INDESIT company

Model type:
BA35FNFPSGR

Commercial code:
F033774

RE0231T0 Exploded views

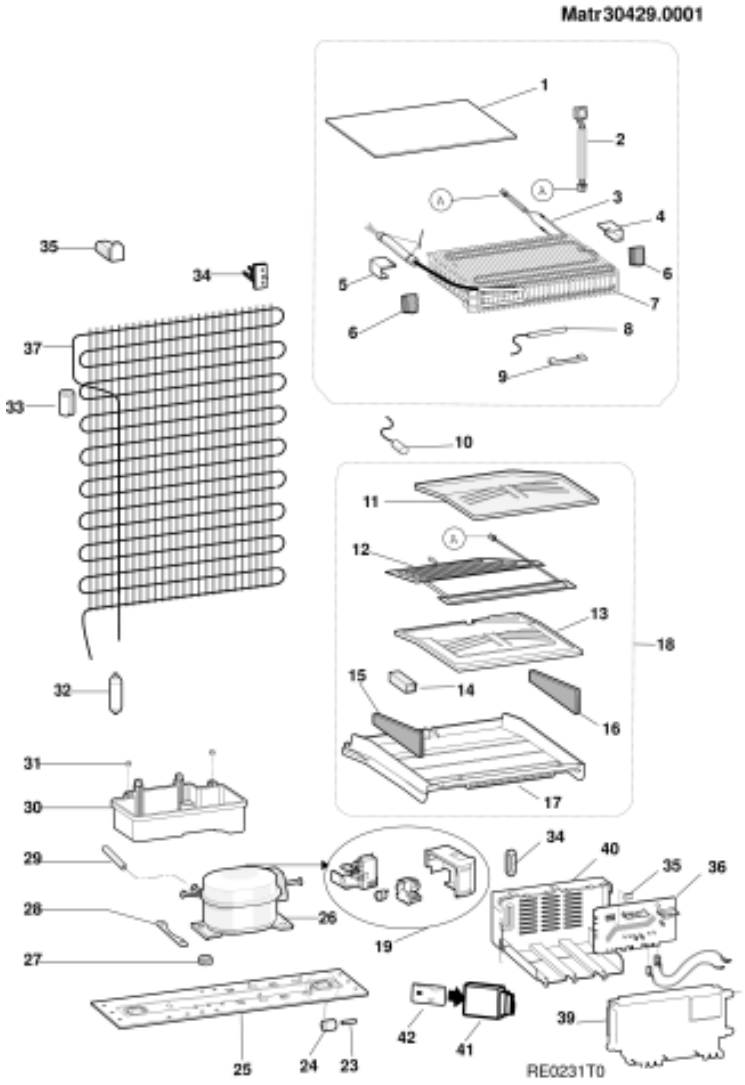
0999364: new fin evaporator and rezistance

Since 01/04/05 new fin evaporator end new rezistance will be used on EU combi models. New parts as an assembly can be used on the appliances which are produced before the modification.

New parts;
115198- fin evaporator
115199- new evaporator rezistance

0999376: ICE FORMATION AT THE BACK OF THE EVAPORATOR

Below modifications have been performed to prevent ice formation at the back of the evaporator on L70 combies. These new parts can be supplied as an assembly C00141277
1- Spugnetta evaporatore left and right have been modified since 12/08/2005. Spare part codes remain the same (C00094468-C00094467). These parts must be replaced together in case of necessity of the replacement.

2- Power of the rezistance for divisorio camere has been increased from 40W to 50W since 03/10/2005. Spare part code remains the same (C00095774).

3- Power of the rezistance for evaporator has been increased from 140W to 150W since 26/09/2005. Spare part code remains the same (C00115199).

4- Drain hose end piece C00141278 has been used for draining the water to the evaporating tray since 26/09/2005.

To fit new evaporator follow below procedure;
· First of all fin evaporator should be positioned at right and back of the freezer roof and than right bracket should be screwed like previous manner (the same track of the hole for right bracket exists on the cabinet). Use the evaporator as a template to screw and position the left bracket symmetricaly.

RE0251T0 Exploded views

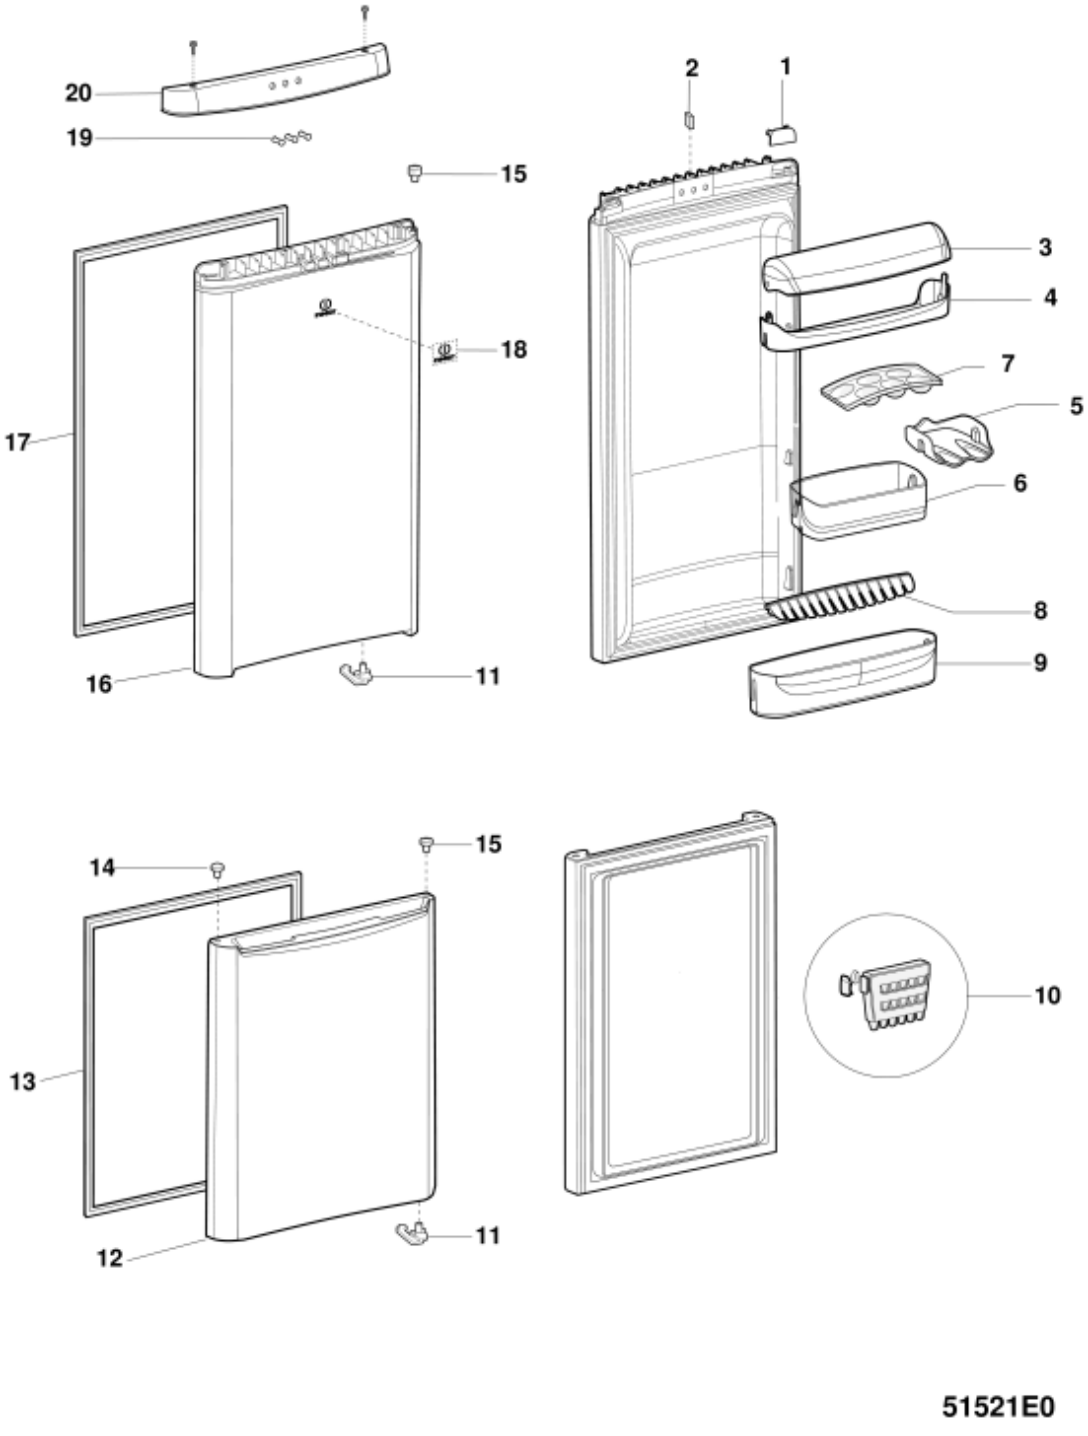
0999368: color modification

Since April 2005, color of products has been changed from Bianco 27 to Polar White in Manisa Plant.

Industrial code has been changed but, commercial code remains the same as you can see in below example.

New spare part codes have been given for the below external parts.

Cabinet, cabinet head panel, door, door head panel, door gasket, kick plate.

The external parts colered bianco 27 are limited with our stock and in the future it will be substituded by polar white parts.

RE0252T0 Exploded views

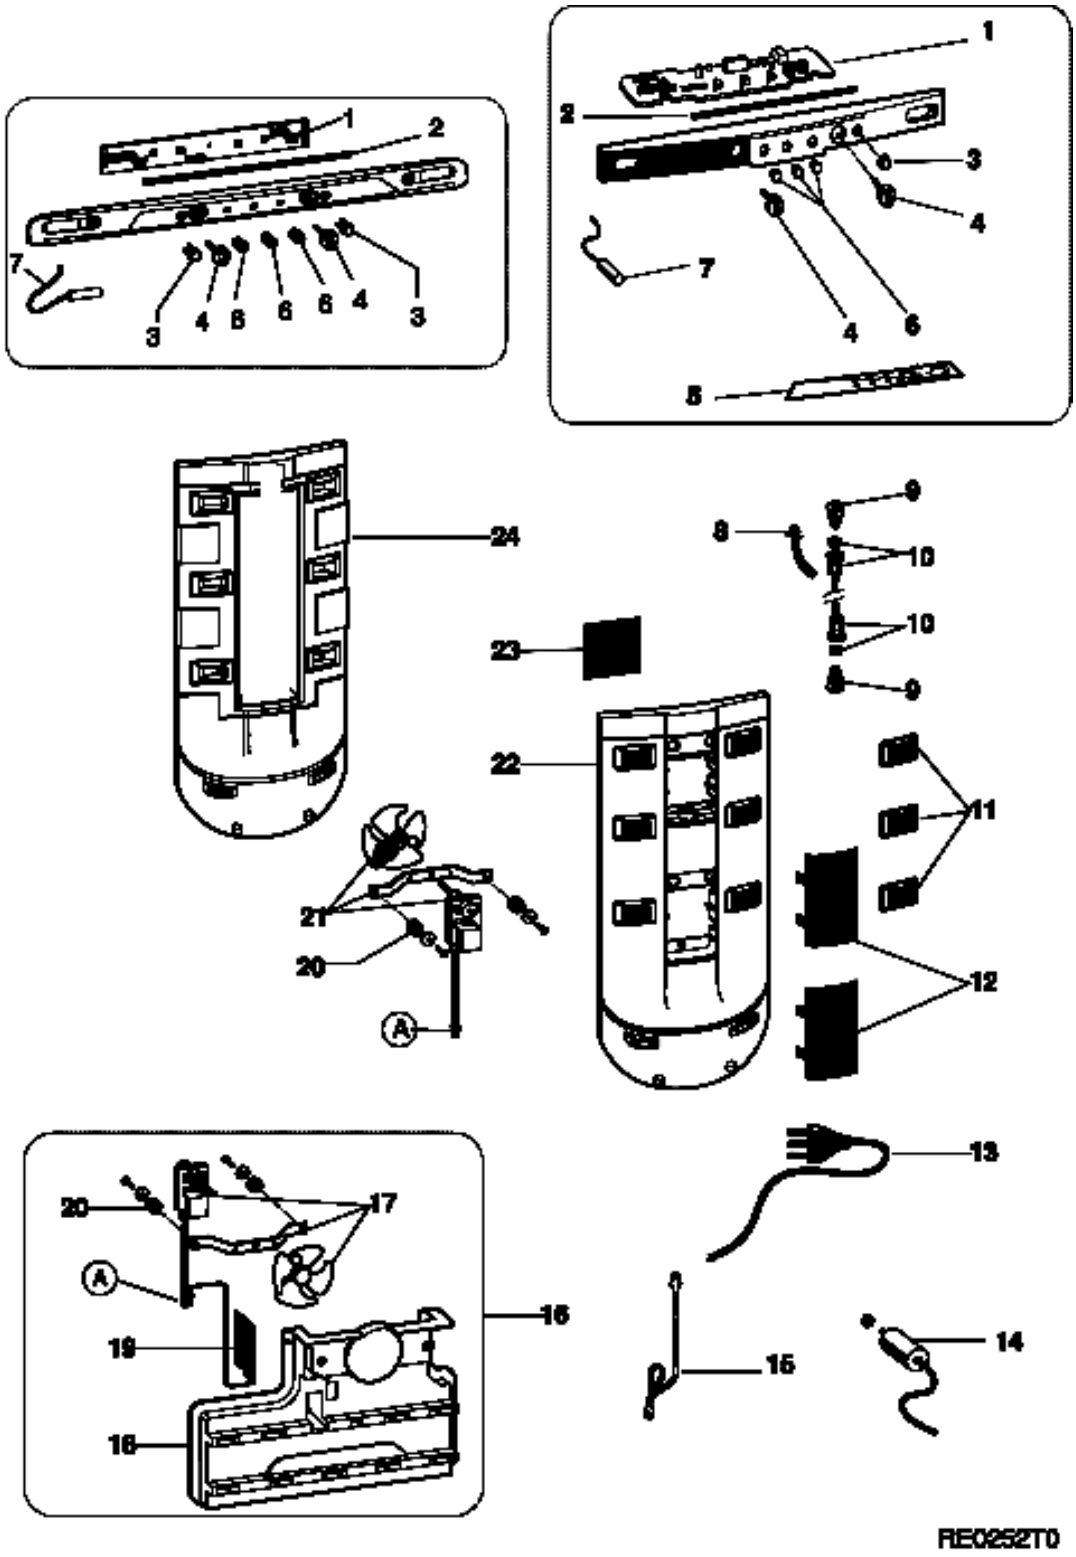
5- Fan motor plastic assembly has been modified. The hole for propeller has been modified to prevent friction between propeller and fan motor plastic since 03/10/05.
Spare part code remains the same (C00116498).

0999379: TWO HOLES HAVE BEEN CANCELLED ON MULTIFLOW FOR COMBIES

Due to low temperature at the lower part of the fridge section on Manisa combies two holes which are placed on multiflow cover have been cancelled for all combies since 13/04/2006.
